## **CALIFORNIA COASTAL COMMISSION**

**A-5-LGB-20-0055 (Donahue)**

**December 9, 2020**

# DONAHUE RESIDENCE ADDITION & REMODEL

**A.1 Determination of the 'Bluff Edge' is inconsistent with LCP certified definition**

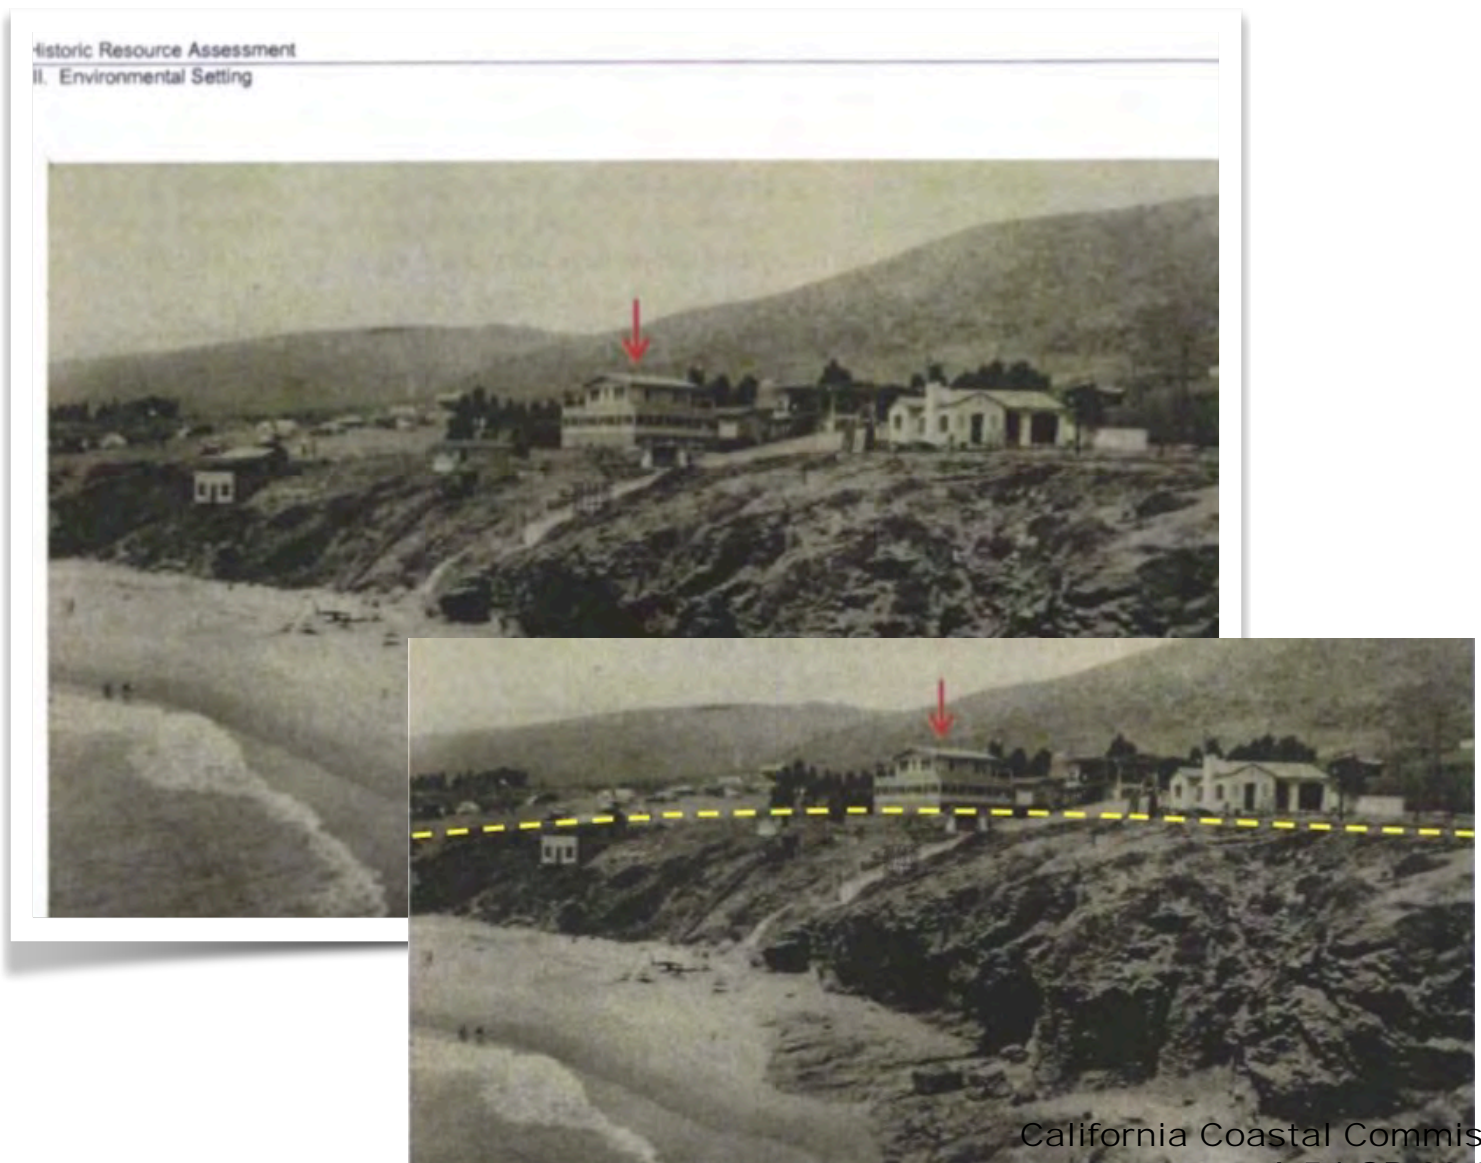
The (certified) Land Use Element Glossary #101 defines the "Ocean Front Bluff Edge or Coastal Bluff Edge":

An accurate determination of the bluff edge is critical. It is needed to then determine the extent of the bluff face and consider what actions to condition (e.g., setbacks, restoration, removal of structures, etc.) as well as to determine if the proposed development complies with the LCP Policies and Actions as shown above.

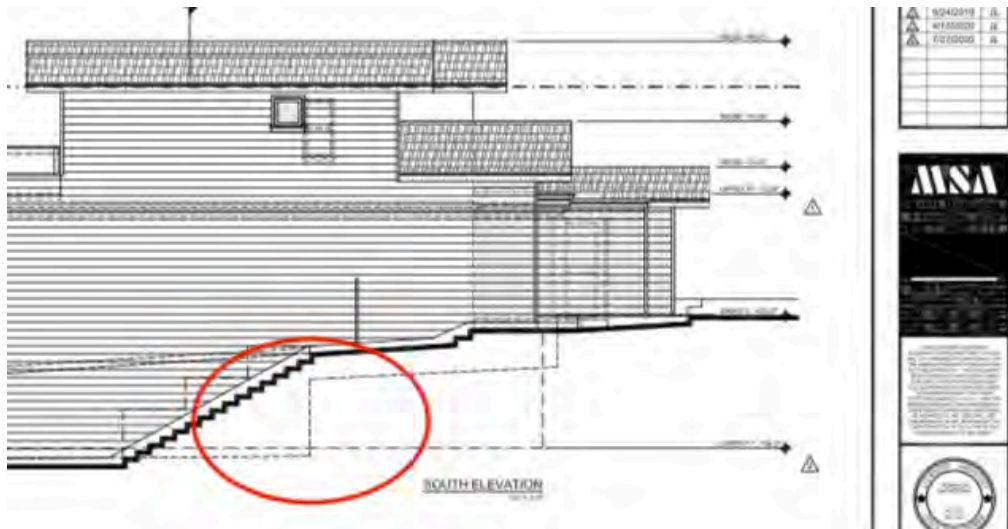
The applicant's proposed project appears to actually move the bluff edge further landward as they are going excavate their addition footage under the existing structure thus likely redefining the bluff edge.

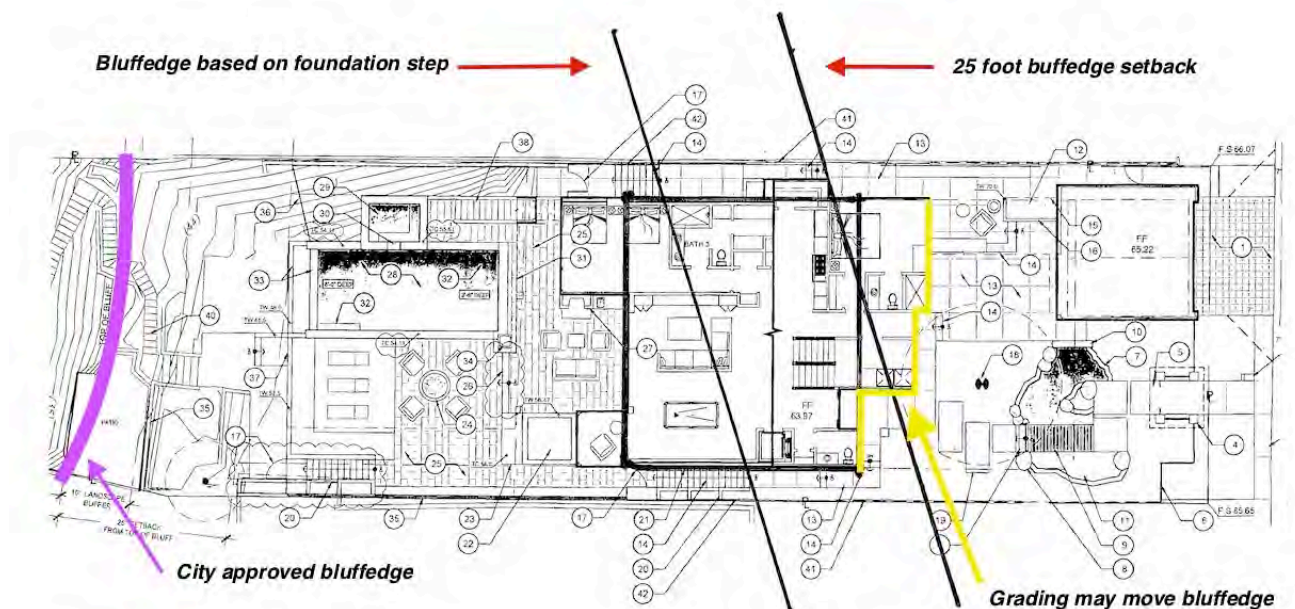
The applicant's submittal shows the foundation making a pronounced step with a similar step up on the upcoast side. Perhaps this is evidentiary to determining the bluff edge, combined with the applicant's own historic photos that clearly show the bluff face intersecting the coastal plain much further inland.

Photos below depict the landform at the Kinstler project (31505 Bluff) (left) and the similar landform at the subject site (right):

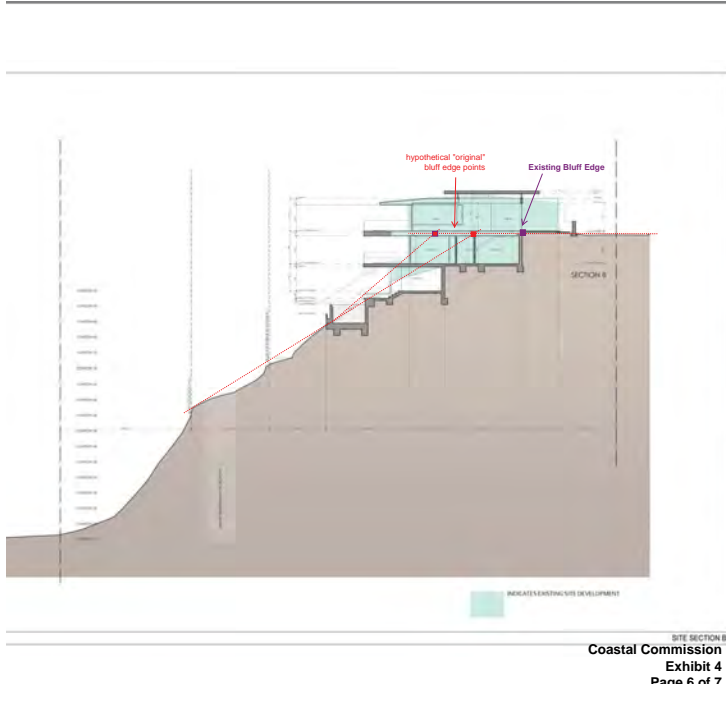
Below is the work product of the appellant depicting the bluff edge:

Figure 11. Rear (south) elevation, view north, of Residence, 2001 (Mark H. Singer Architects)

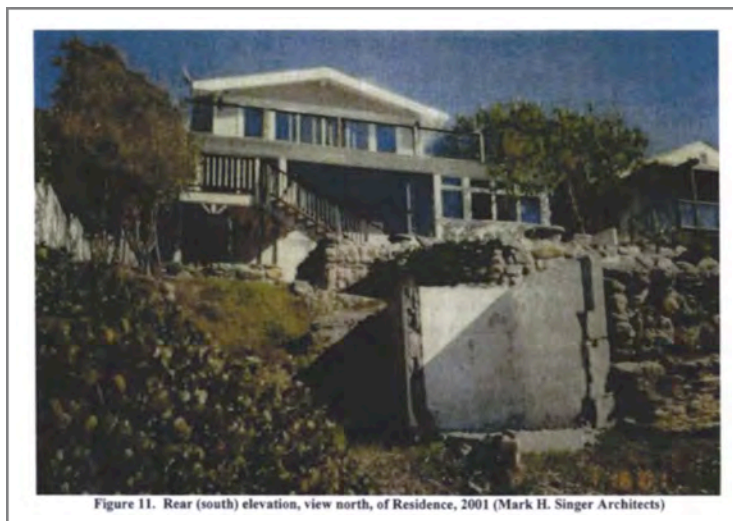
The color photo below (from 2001) shows a concrete remnant from the second home on the coastal bluff. It is unclear if this was removed via the 2001 project that did not obtain a CDP as there are no building permits for that work in the City's file. If the 2001 Design Review approval was carried it, it would constitute unpermitted work.
